ROAD SAFETY AUDIT

Title: STAGE 1 ROAD SAFETY AUDIT

Office Innovation Campus, Moygaddy, Co. Meath.

Report reference: 1388R01

General Comment tie-in points

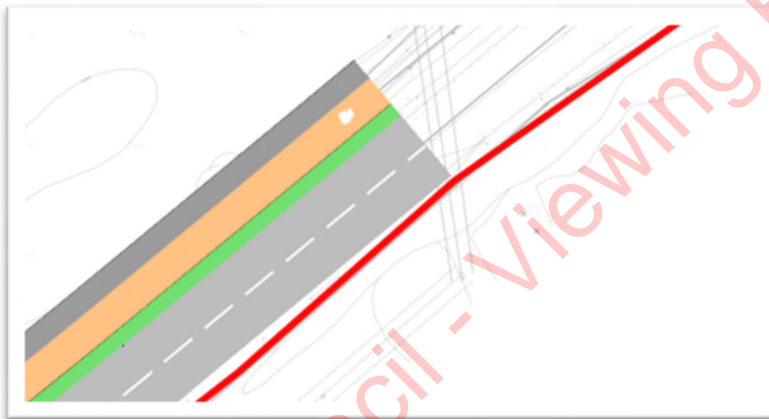
Details have not been provided of how the cycle track and footpaths will tie in at the scheme extents. Cyclists and pedestrians will have to cross the carriageway to access the facilities. Without suitable transitions from off road to on road and suitable crossing facilities there is a risk that pedestrians and cyclists will be struck by passing traffic.

It is recommended that suitable transitions and crossing facilities be provided.

3.1	Y	Y	The proposed cycle lane along the R157 eastern arm will be updated to tie into the carriageway. A suitable Jug turn will be provided on the opposite side of the road to accommodate the cyclists' right turning movement towards the development	Yes

Drawing S665- OCSC-1A-MH-DR-C-0111 S2 P01 Sheet 2 of 3, cycle track across campus access road.

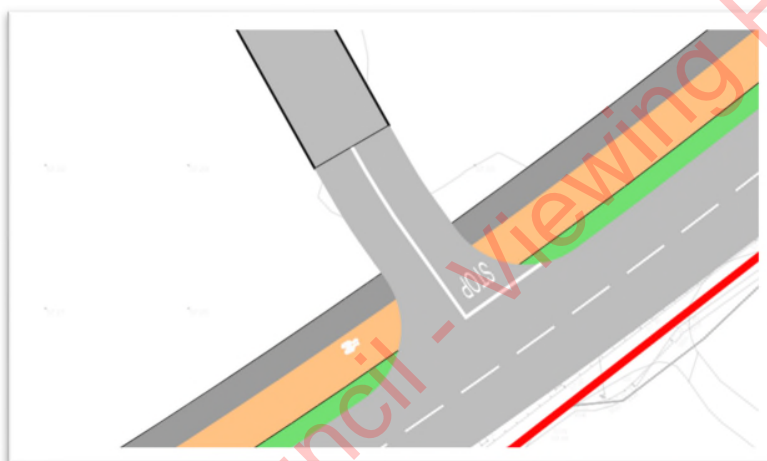
The proposed two way cycle track crosses the mouth of the campus access road. There is a risk that drivers exiting the campus may not expect two way cyclists as they approach the stop line.

It is recommended that a 'bend out crossing' be provided.

3.2	Y	N	It is proposed to provide a shared space and tactile for crossing before the cyclist and pedestrians approach the junction. A raised crossing will be provided to indicate priority for pedestrians and cyclists.	Yes

Drawing S665- OCSC-1A-MH-DR-C-0111 S2 P01 Sheet 2 of 3, campus access road.

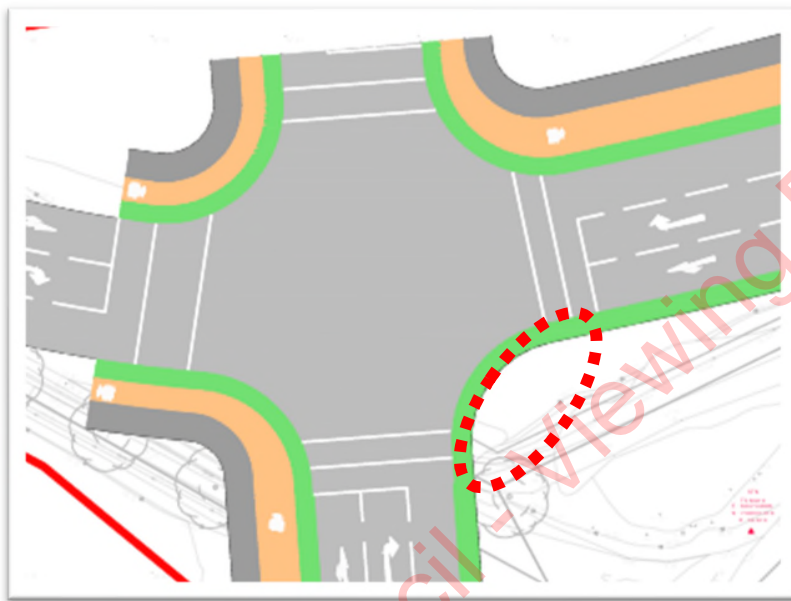
There is a signalised pedestrian crossing of the R157 eastern section, however there is no footpath on that side. This could lead to slips and falls if pedestrians cross into the grassed verge.

It is recommended that a section of footpath be provided linking the north-south and east west pedestrian crossing areas. The crossing should be retained to be able to cater for potential future development.

3.3	Y	Y	A shared facility has been provided within the campus at required widths which ties into the external pedestrian and cyclist network.	Yes
3.4	Y	N	There are insufficient spaces to provide walkways and cycle lanes along the south-eastern parts of the design (boundary wall). As such, two way movements will take place on the opposite sides. Pedestrian crossing lines have been removed from the junction on the eastern and southern legs.	Yes

Drawing S665- OCSC-1A-MH-DR-C-0115 S2 P01, Visibility Splay at Campus junction.

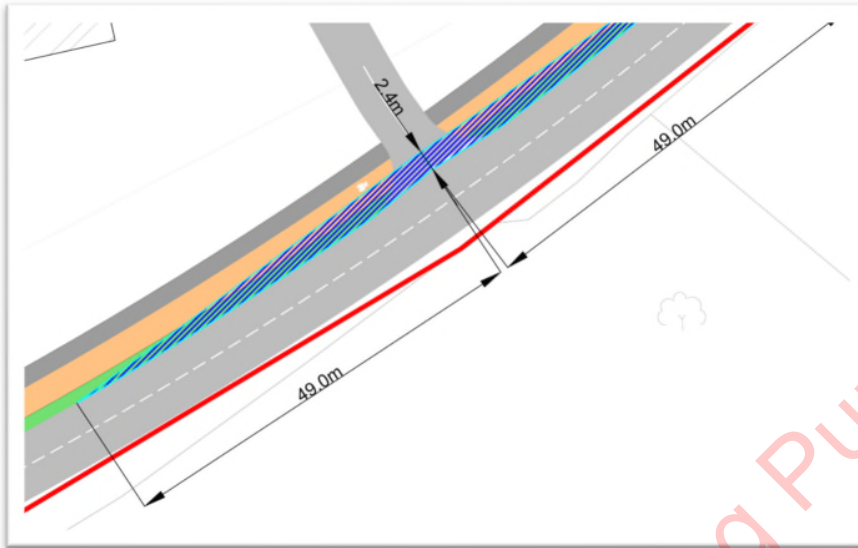
The visibility splay is shown for a 50km/hr urban design speed. The posted speed is 80km/hr. There may be insufficient visibility to oncoming vehicles leading to side-impact or rear-end collisions.

It is recommended that visibility splays be provided to match the anticipated 85th percentile speed post opening.

3.5	N	N	The visibility splay is achieved for 50kph. The speed limited will be lowered to 50kph once the new	Yes

distributor road and development is completed	
3.6	Y	Y	It is proposed to utilize the existing R157 road alignment as an off-road trail truck. The gate can be accessed via this trail in future once the development is completed.	Yes
3.7	Y	N	The proposed 1.5m verge separation is an improvement to the existing condition. As the section of road is fairly straight and the speed is being reduced, it is not anticipated that this would be a problem.	Yes

Drawing S665- OCSC-1A-MH-DR-C-0111 S2 P01 Sheet 2 of 3, Carton Estate gate.

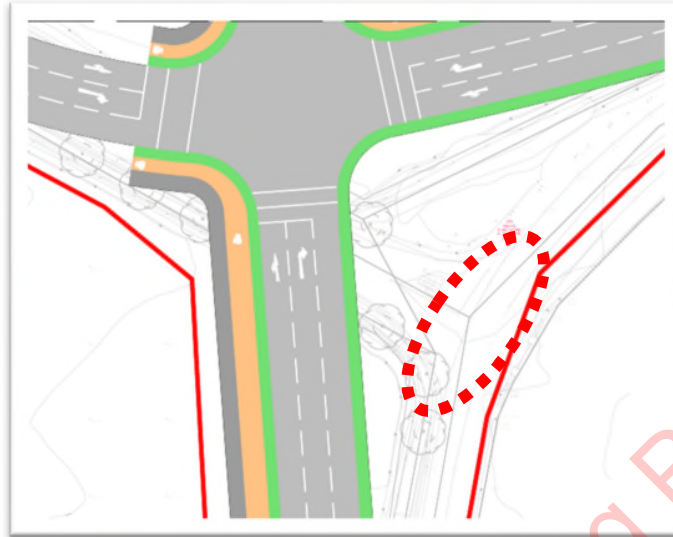
There is an existing gate into the Carton estate close to the proposed signalised junction. It is unclear if this gate will be used in the future. If it is to be used movements into and out of it may lead to collisions at the junction.

It is recommended that the accommodation works relating to this gate be included in the design process.

Drawing S665- OCSC-1A-MH-DR-C-0111 S2 P01 Sheet 2 of 3, Carton Estate boundary wall.

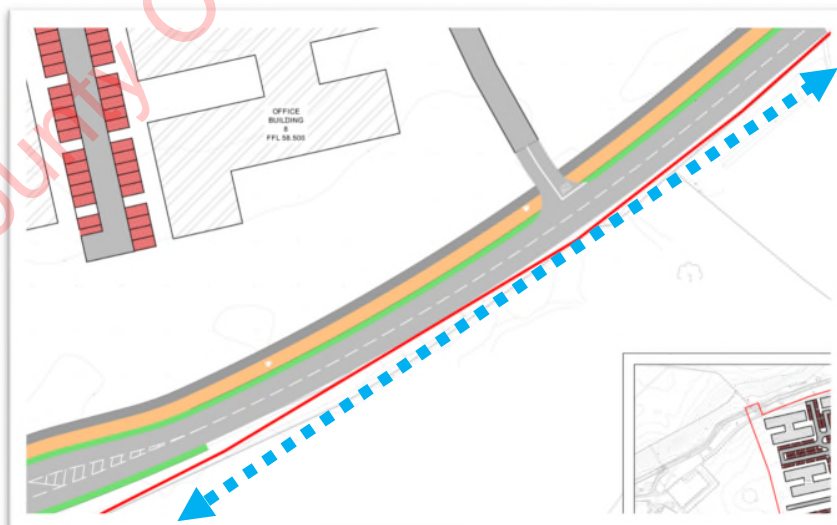
The realigned R157 eastern arm is very close to the stone wall of the Carton Estate. This is a hazard for an errant vehicle.

It is recommended that a suitable Clear Zone be provided between the boundary wall and the realigned carriageway.
